HUNTS GROVE
GLOUCESTERSHIRE

Section 73 Planning Application

ADDENDUM TO THE DESIGN & ACCESS STATEMENT

June 2015

PARCEL PLAN

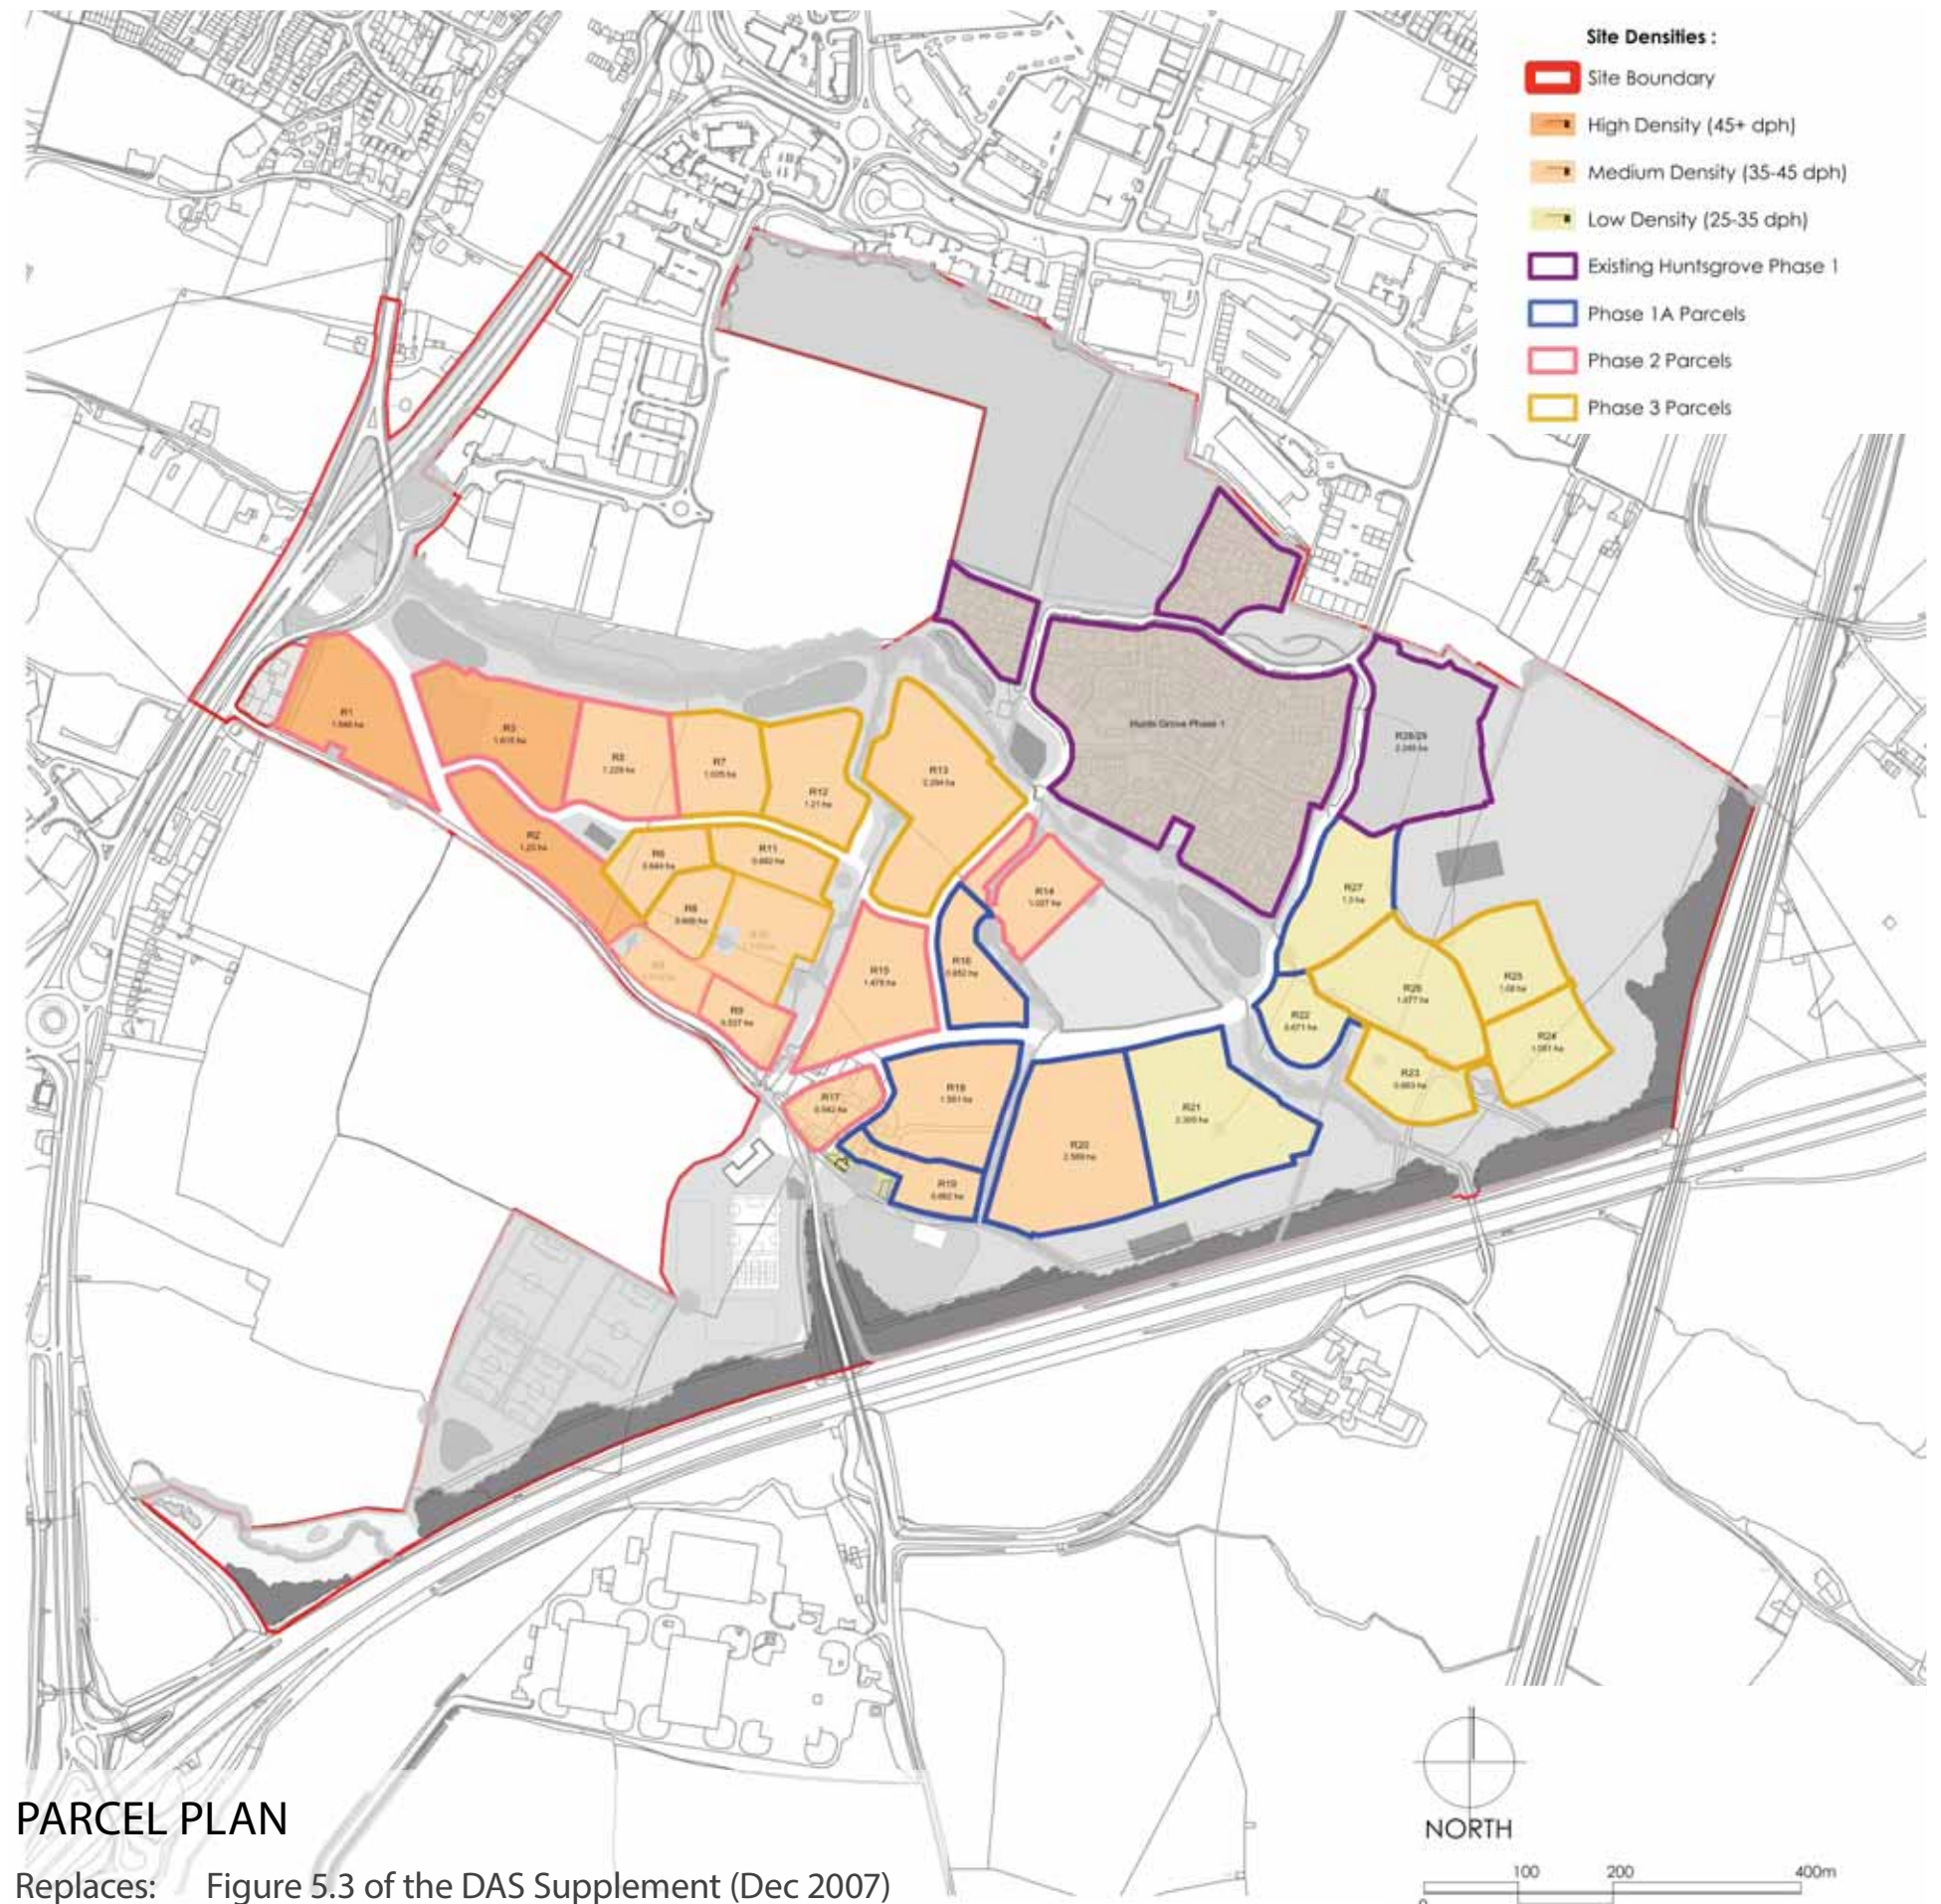
KEY CHANGE

- *Highest densities towards western end*

SOLAR ORIENTATION PLAN

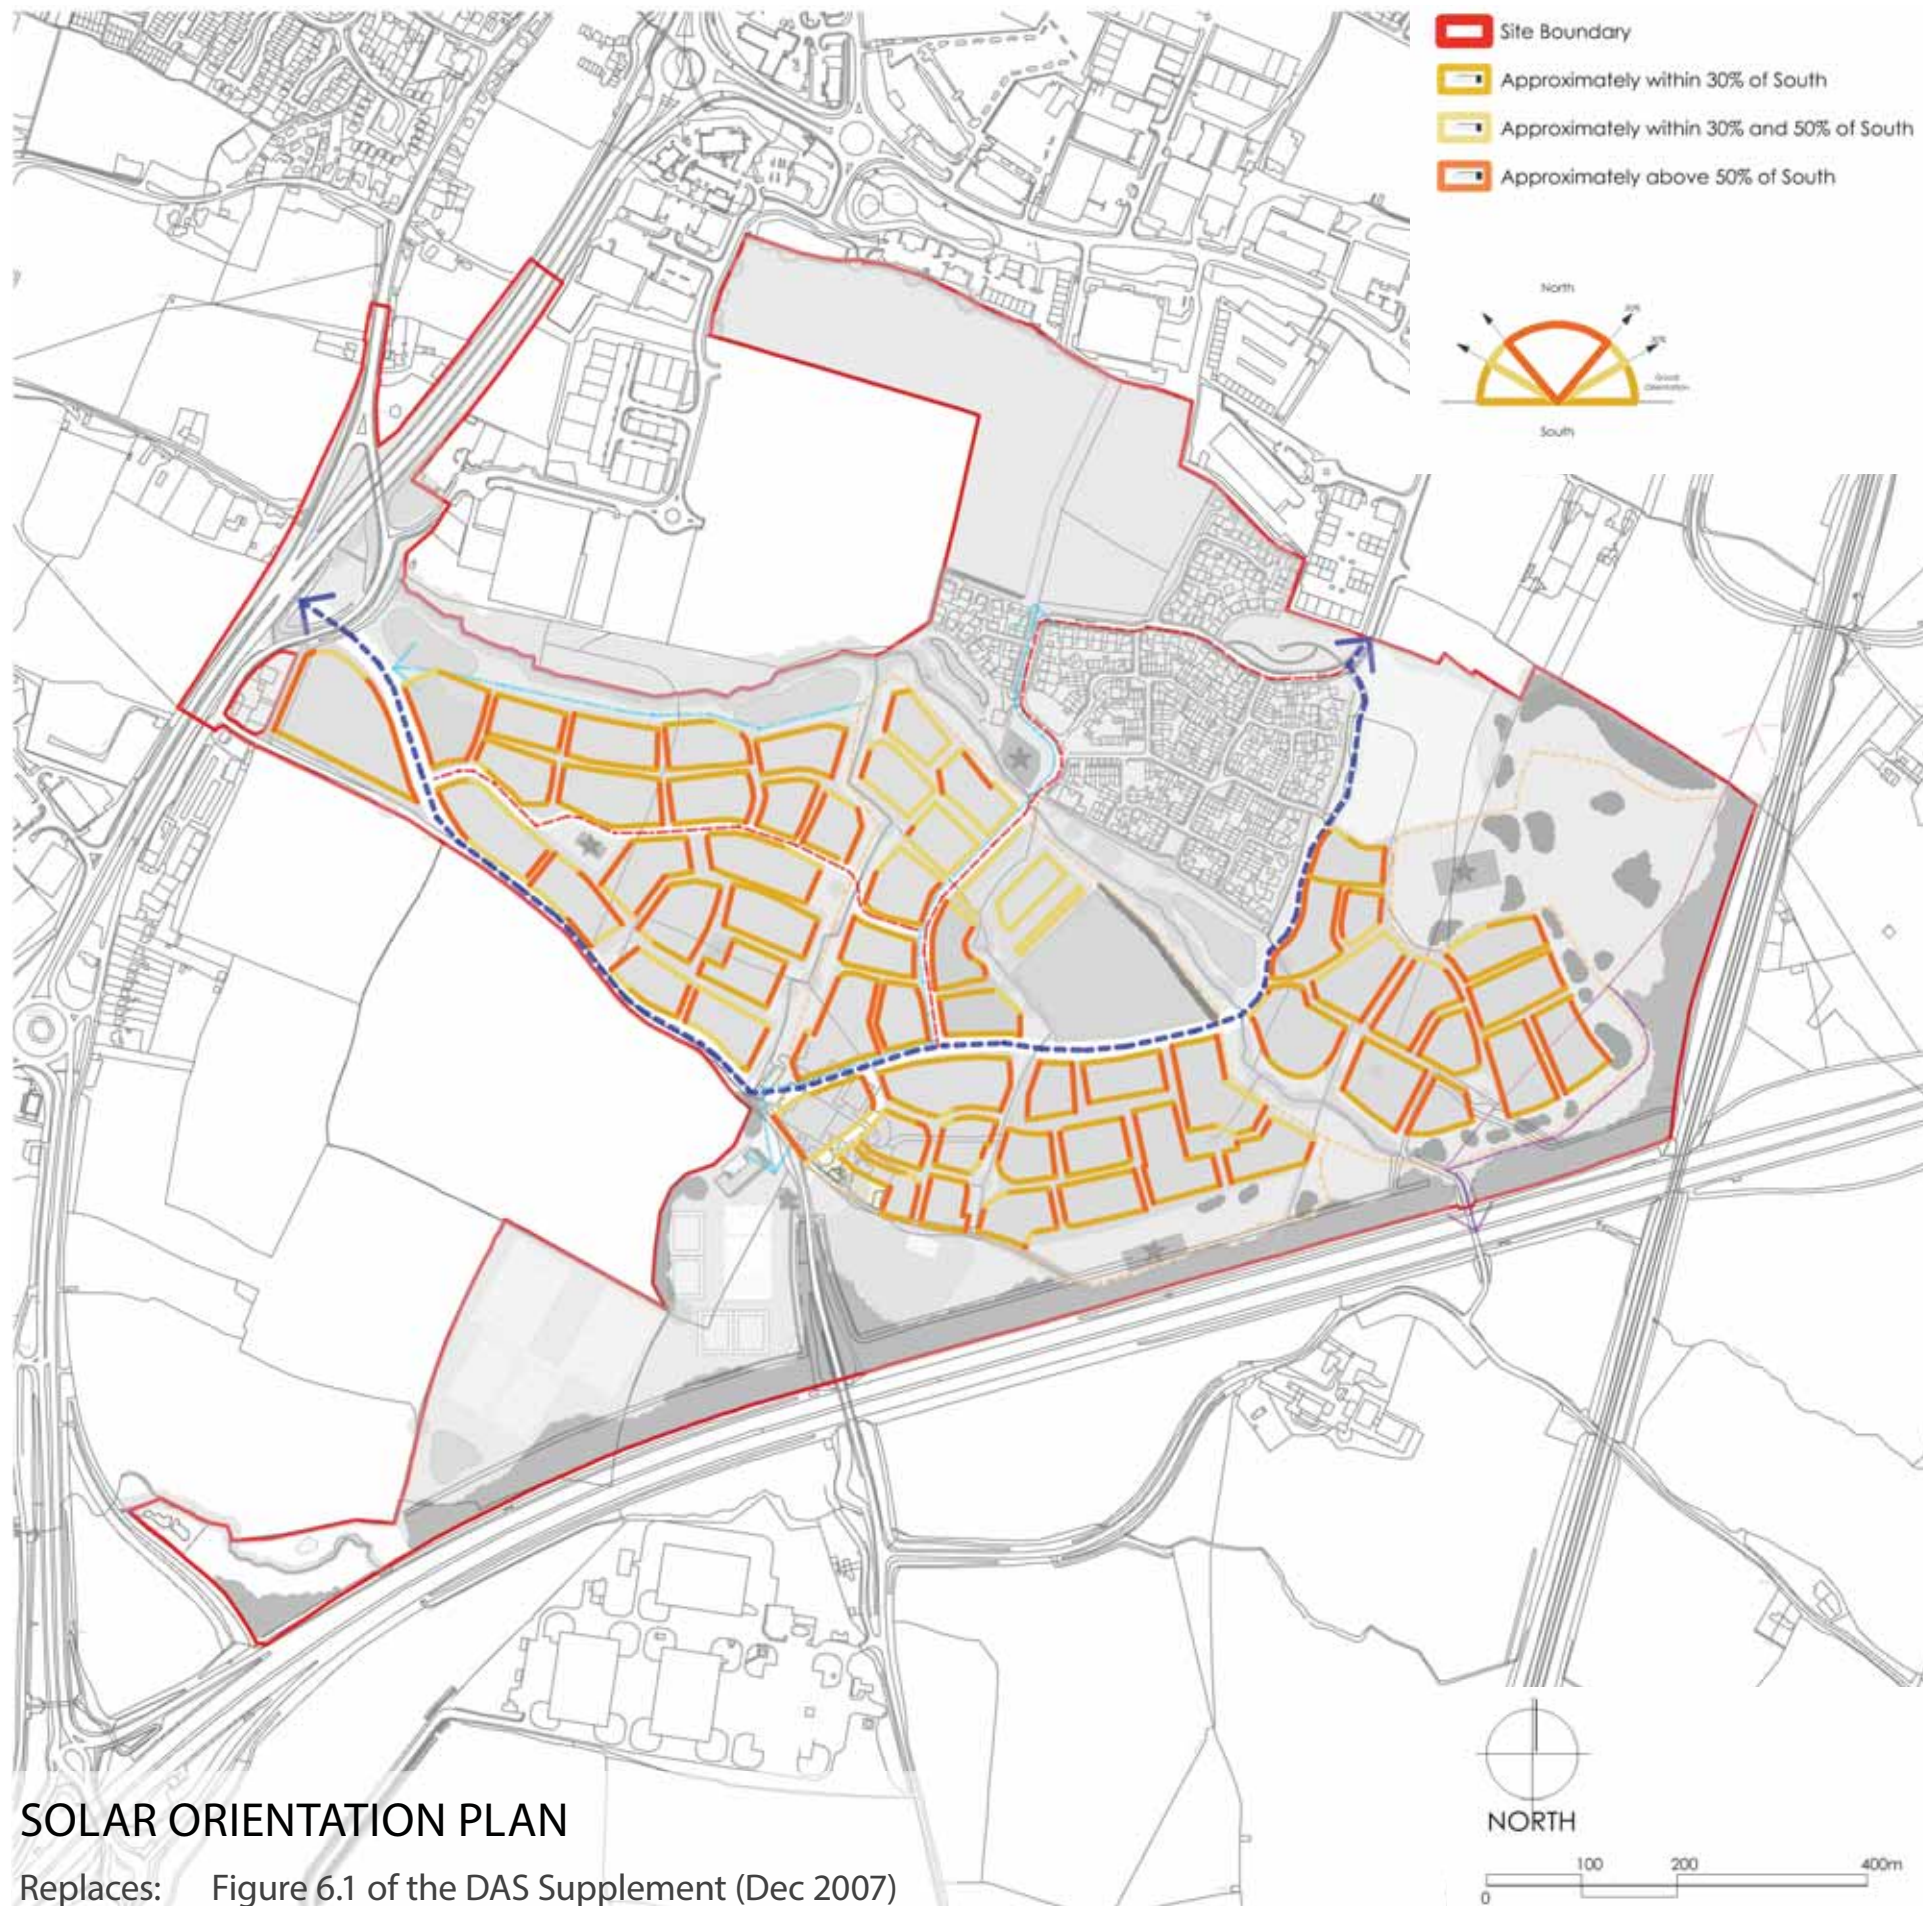
KEY CHANGE

- Increase in south facing elevations
